MAP OF SURVEY

LOCATED IN:
THE S.E. 1/4 OF SECTION 2, T.37S., R.2W., W.M.
IN THE CITY OF CENTRAL POINT, JACKSON COUNTY, OREGON

17883

AFFIDAVIT OF CORRECTION
pursuant to O.R.S. 209.225

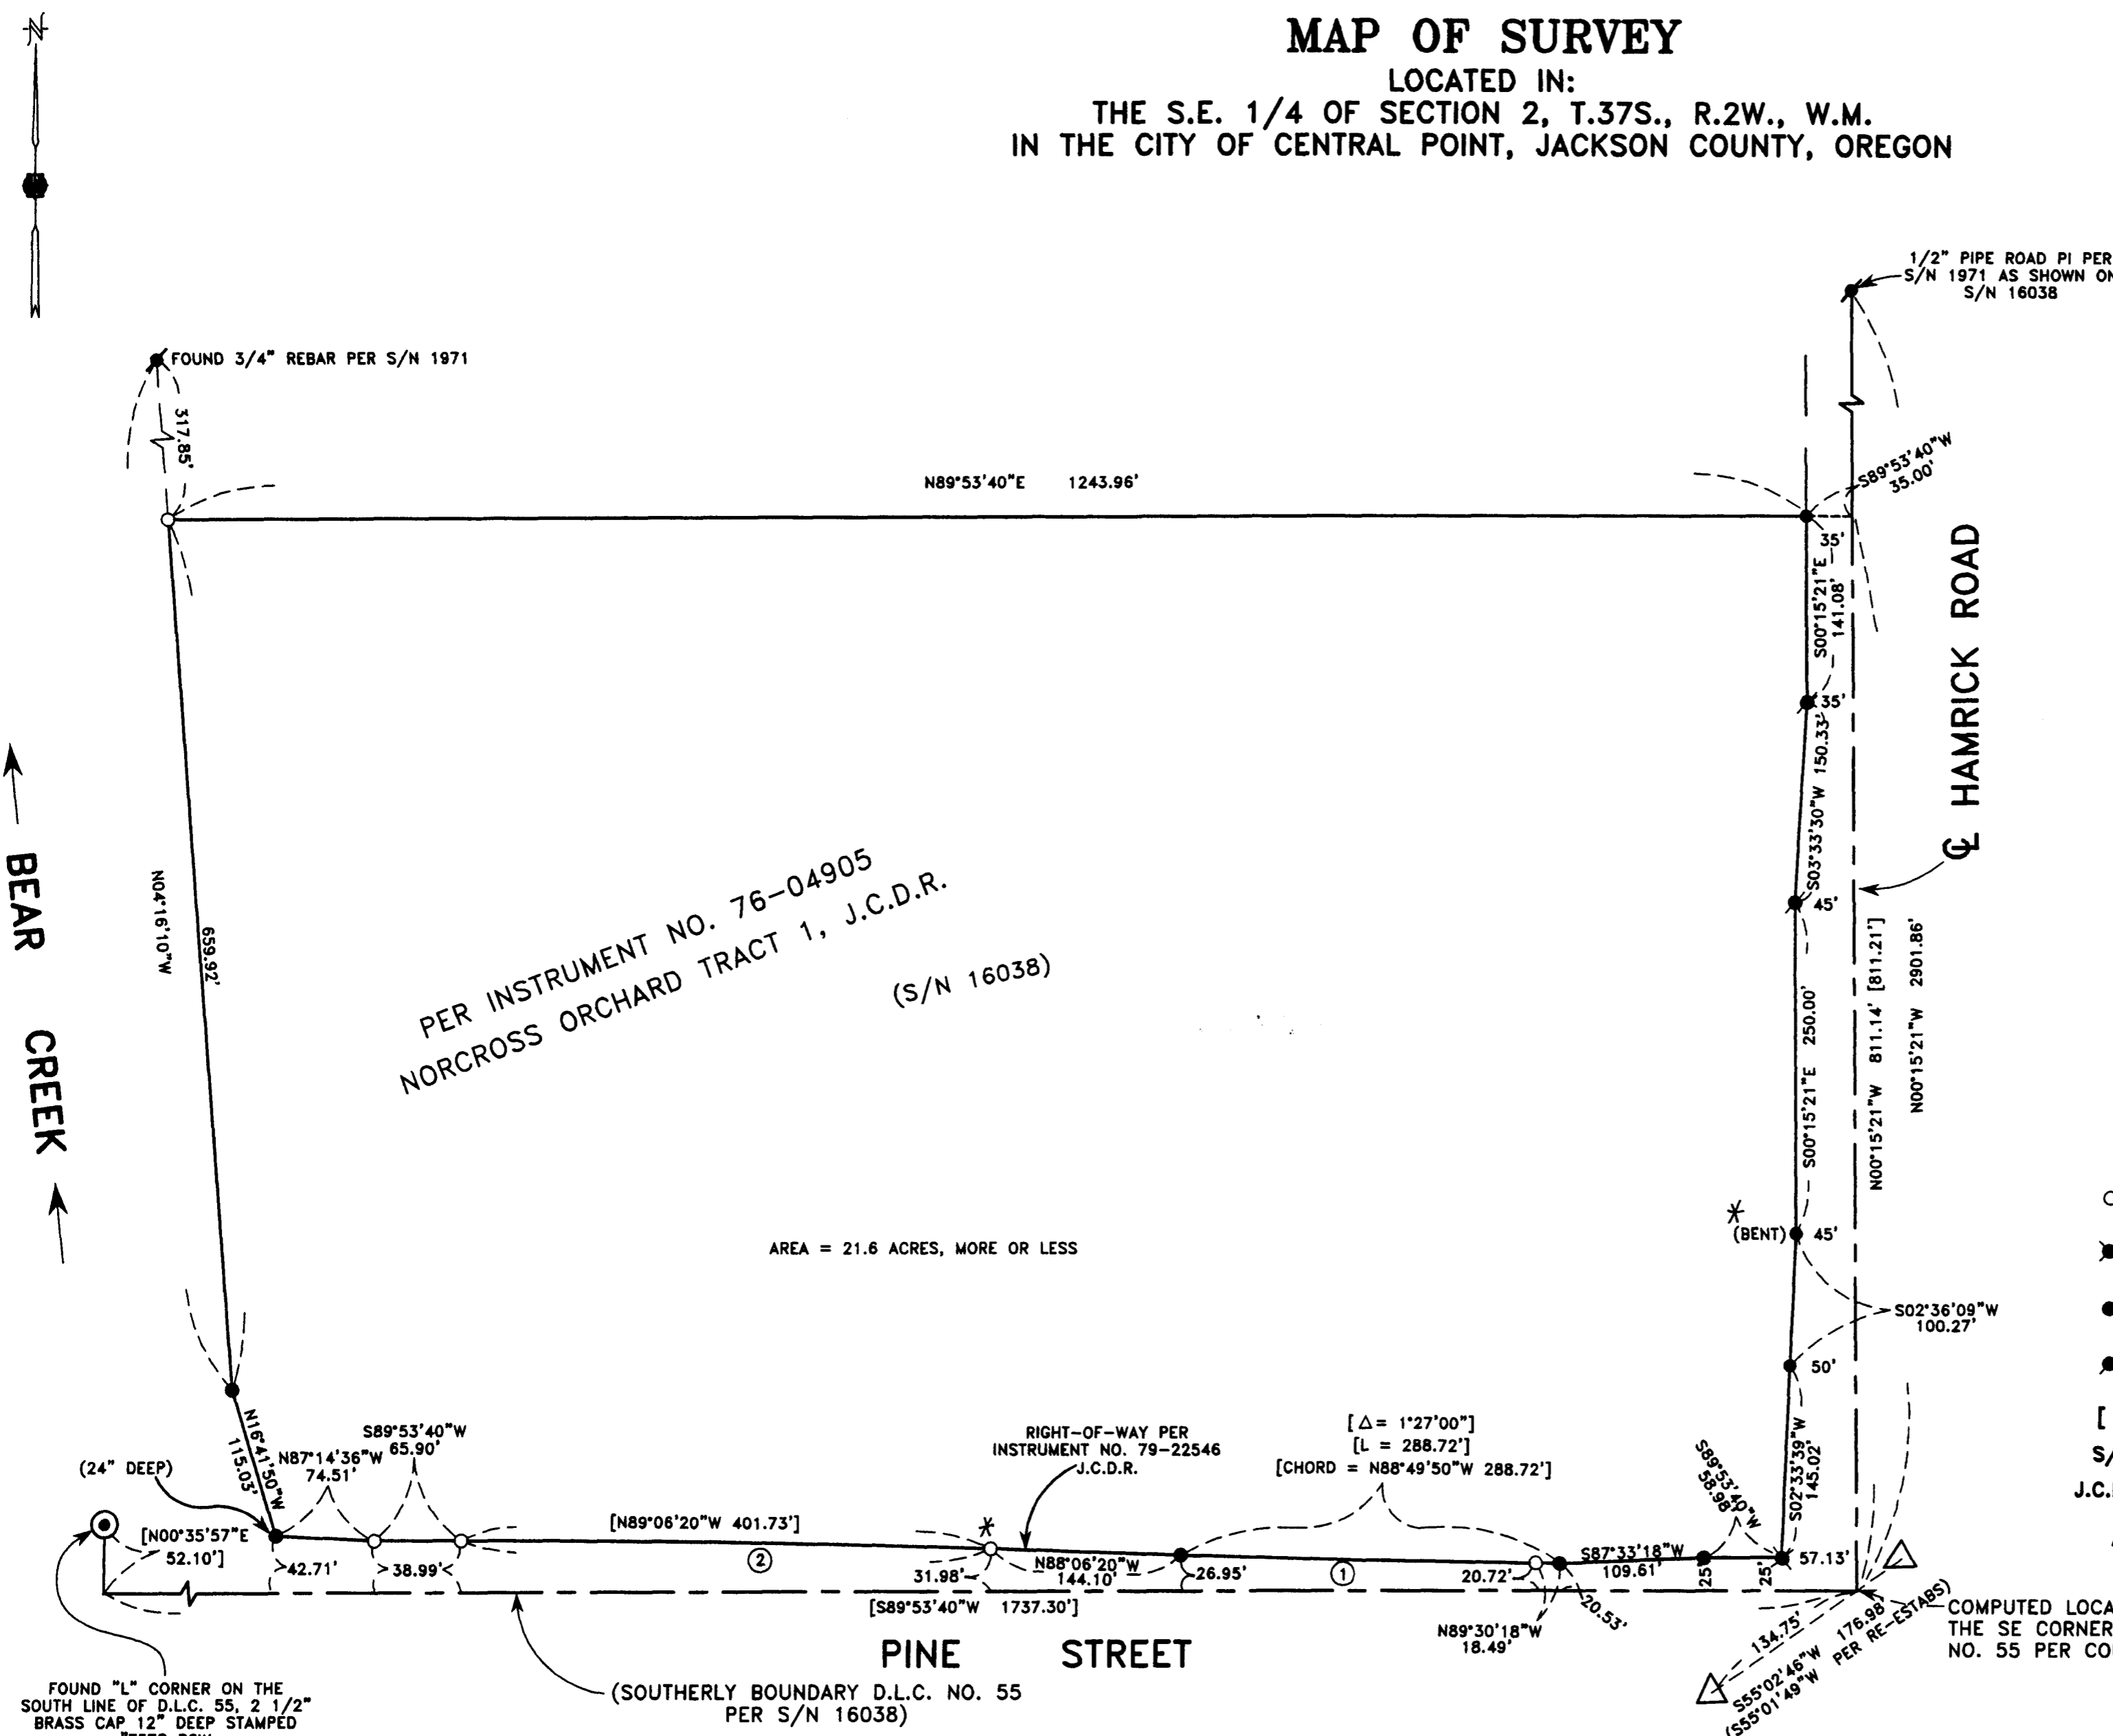
I, Darrell L. Huck, a Registered Professional Land Surveyor of the State of Oregon, No. 2023, do hereby state that it has been discovered that two monuments on Map of Survey done by Douglas C. McMahan and filed as Survey No. 17883 in the Office of the Jackson County Surveyor, were identified incorrectly. Also it should be noted that other monuments had been set within the boundaries of subject property for a proposed subdivision (PEAR BLOSSOM CENTER SUBDIVISION, PHASE 1). Proposed lot corner and proposed right-of-way dedications were monumented. Application for final plat was made to City of Central Point and to the Jackson County Surveyor. However the owner decided to drop the plan for the subdivision. All monuments pertinent to the proposed development except as shown on filed Survey No. 17883 were removed. The monuments removed included monuments identified on filed Survey No. 17759 as monuments No. 102, 103 and 105-110.

- The corrections are:
- 1.) The monument at the Southerly end of the course labeled "S00°15'21"E 250.00'" should be identified as a set 5/8"x24" rebar with plastic cap stamped "D.McMAHAN LS 1913".
 - 2.) The monument at the Westerly end of the course labeled "N88°06'20"W 144.10'" should be identified as a found 5/8" rebar with plastic cap stamped "RANDY L. FITCH LS 2867"
